**SUBJECT:** MOONEY ULTRA INTERIOR DOOR HANDLE UPGRADE

**MODELS/ SN AFFECTED:** M20U OVATION ULTRA 32-0002 thru 32-0005  
M20V ACCLAIM ULTRA 33-0002, 33-0003, 33-0005

**SERVICE INSTRUCTION SIM20-130**  
Date: SEPTEMBER 20, 2018

Figure SIM20-130-1 - EXISTING INTERIOR DOOR PANEL AND HANDLE ASSEMBLY

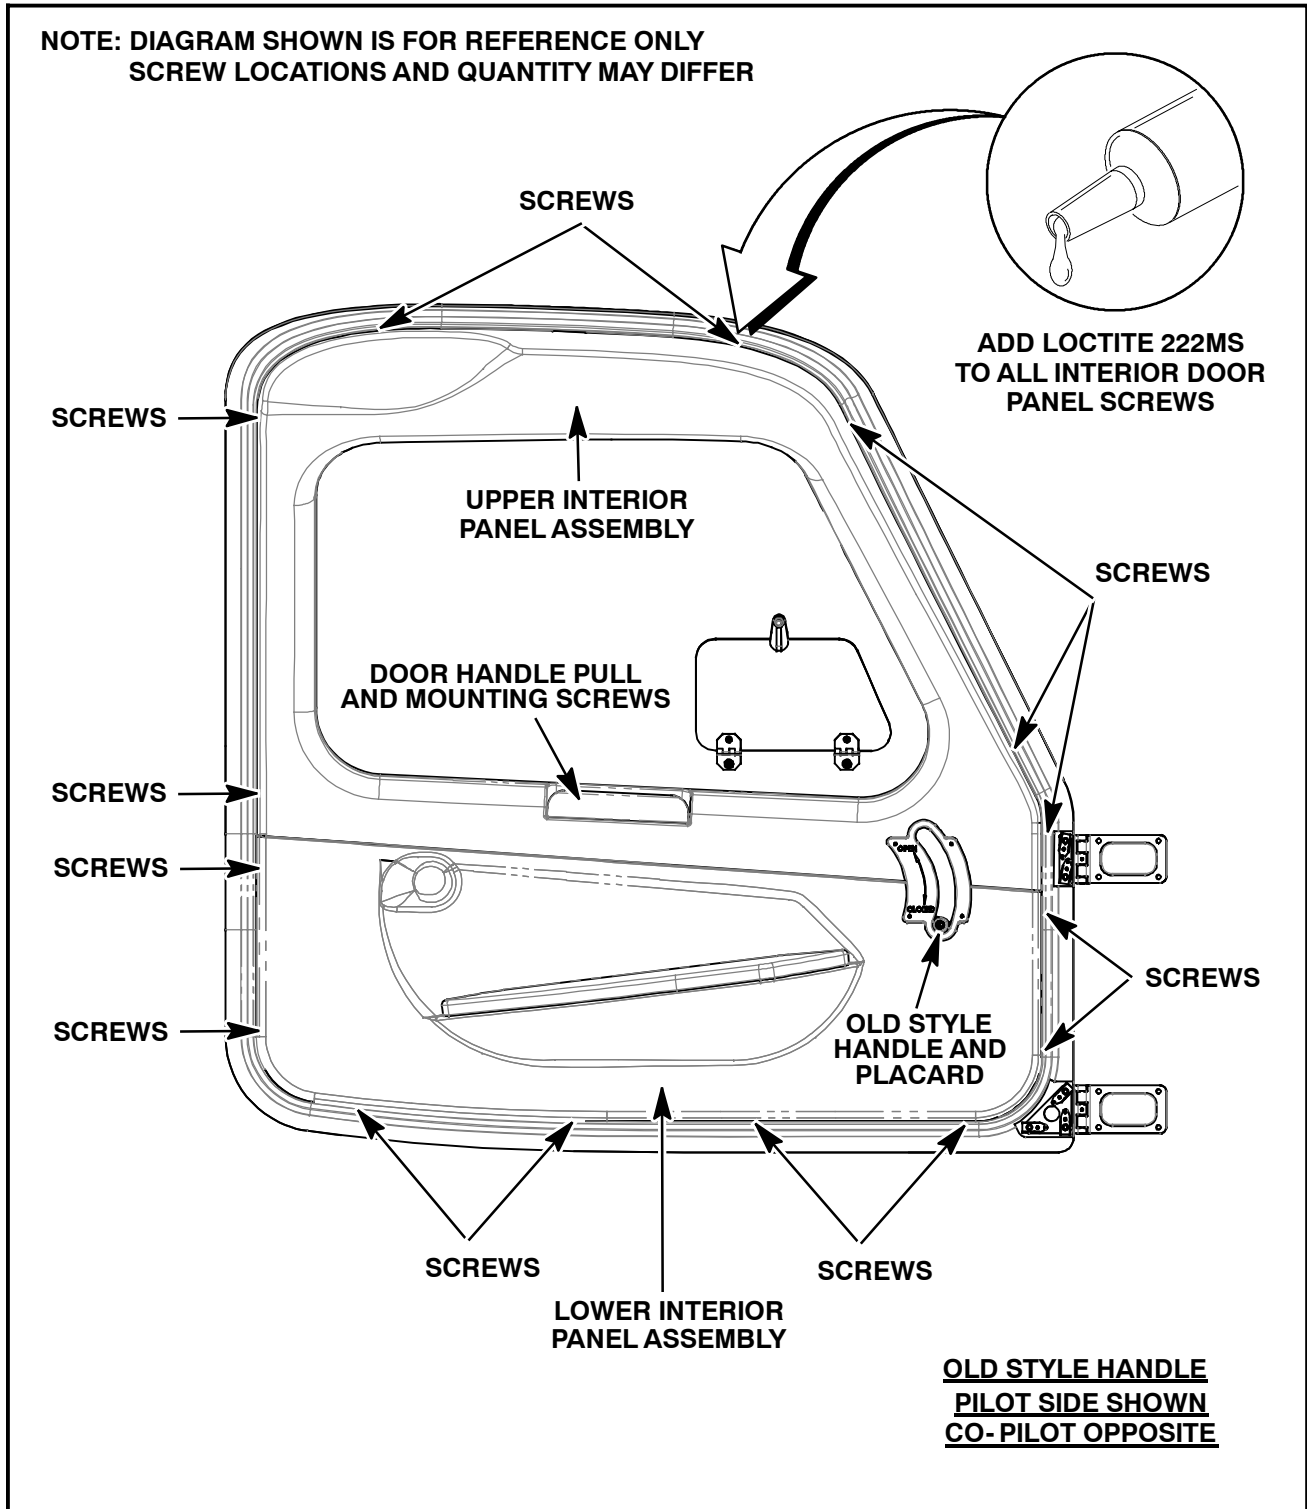
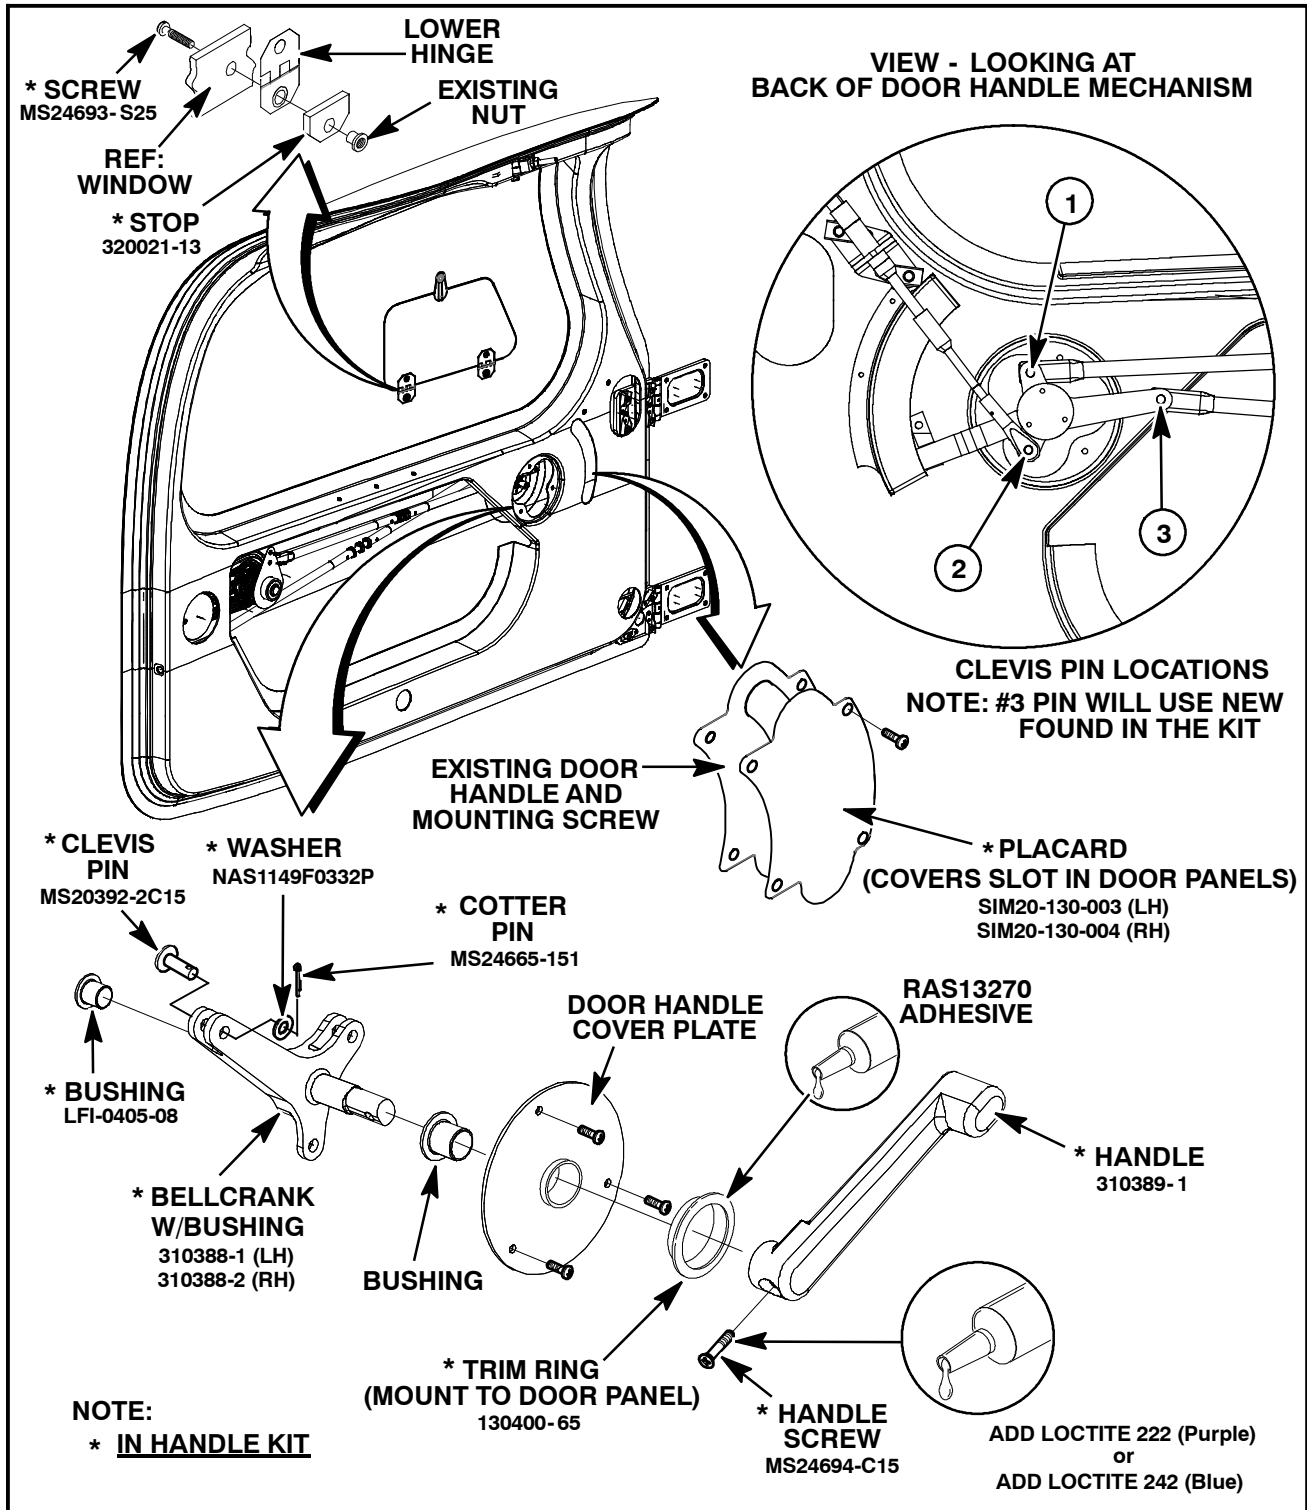
- 1.1. On Pilot and Co-Pilot side entrance doors, cover wing walk area with protective cover.
- 1.2. Open Pilot and Co-Pilot doors, remove interior door handle placard screws, and remove placard as shown in Figure SIM20-130-1.

- 1.3. Remove door handle pull screws and remove upper and lower interior door panel screws, keep for reassembly, remove panels from door as shown in Figure SIM20-130-1.

- 1.11. Carefully cutout a hole thru panel for bellcrank arm to protrude, see figure SIM20-130-2.
- 1.12. Install Upper and Lower interior door panels, use loctite 222MS on screws and secure panels as shown in Figure SIM20-130-1.

**Figure SIM20-130-2 - INTERIOR DOOR HANDLE MECHANISM AND STORM WINDOW**

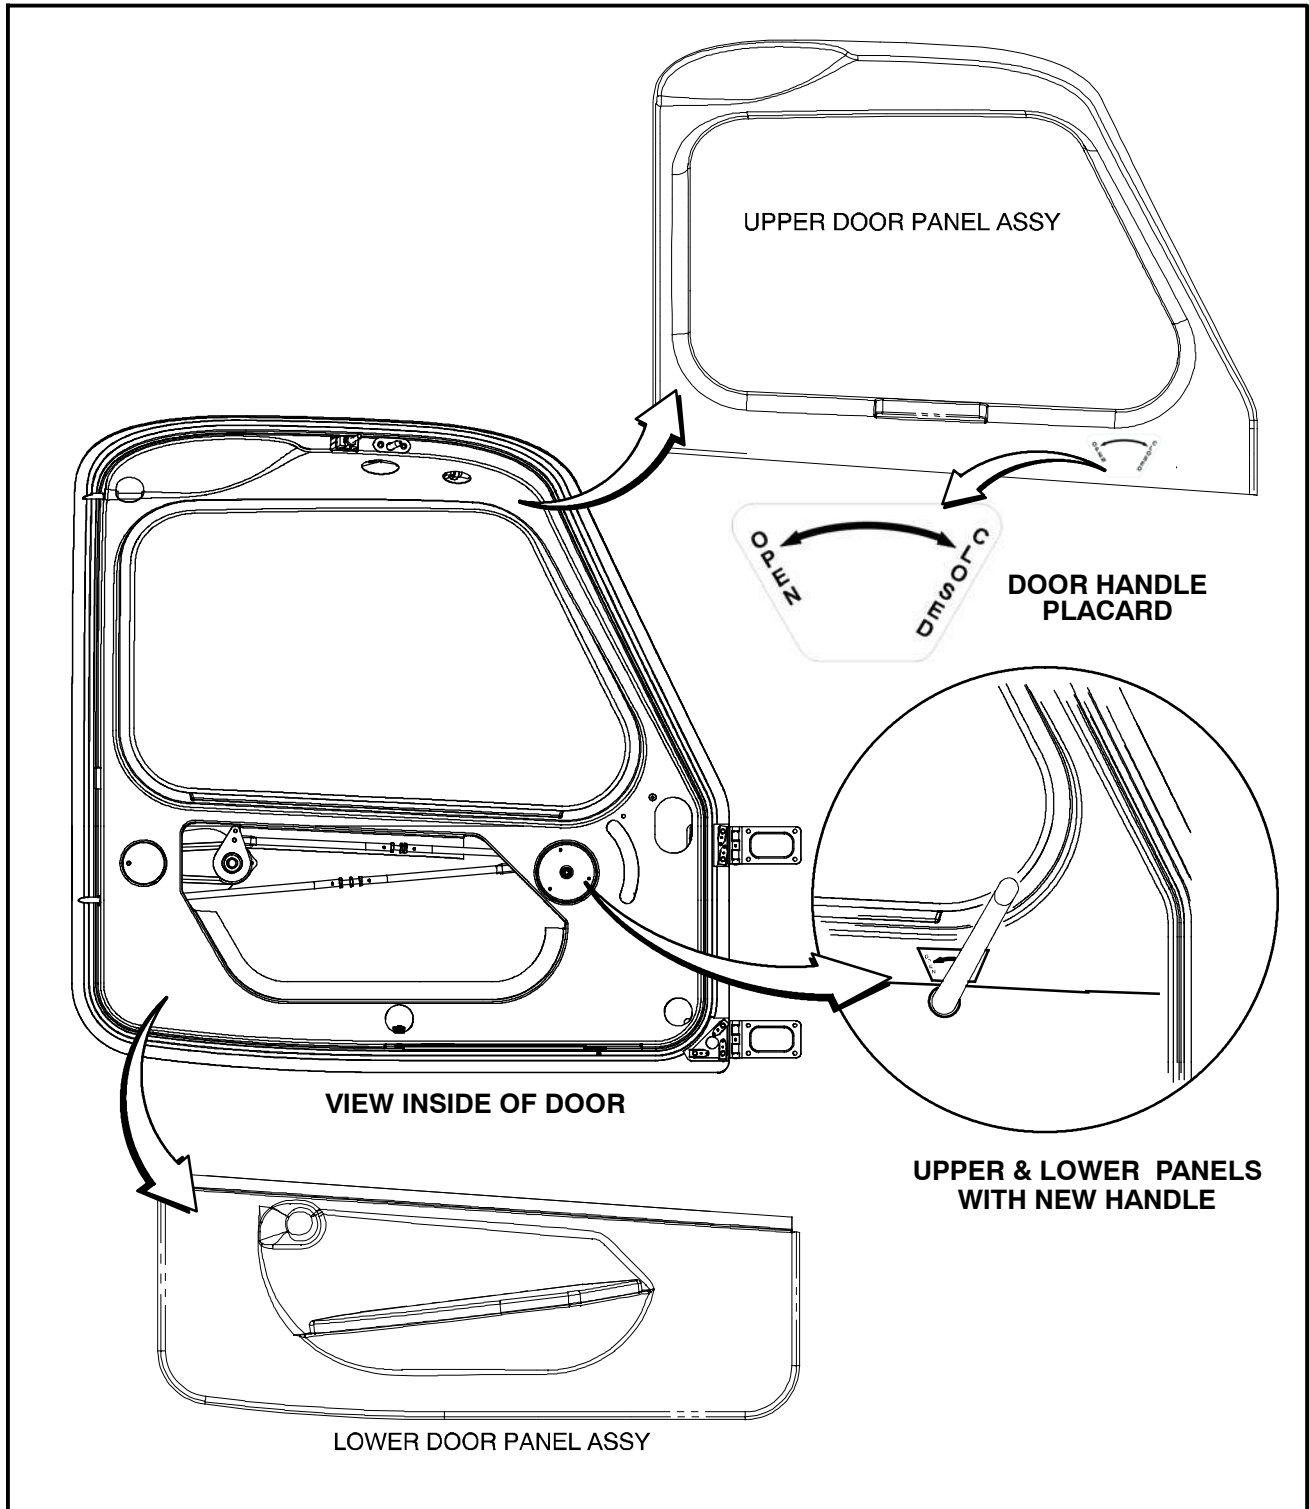
- 1.6. Install new bushing LFI-0405-08 into bellcrank and install into door. Due to tight clearance, it may be helpful to temporarily install clevis pin #3 into bellcrank hole and temporarily secure with a cotter pin before installing into position. Install #1 and #2 clevis pins, washers and new cotter pins. On # 3 clevis, carefully pull temporary cotter pin out, slide clevis pin out far enough to install clevis, push #3 clevis pin thru and add washer, secure with new cotter pin. See figure SIM20-130-2.

- a. Remove lower hinge screws, see Figure SIM20-130-2.
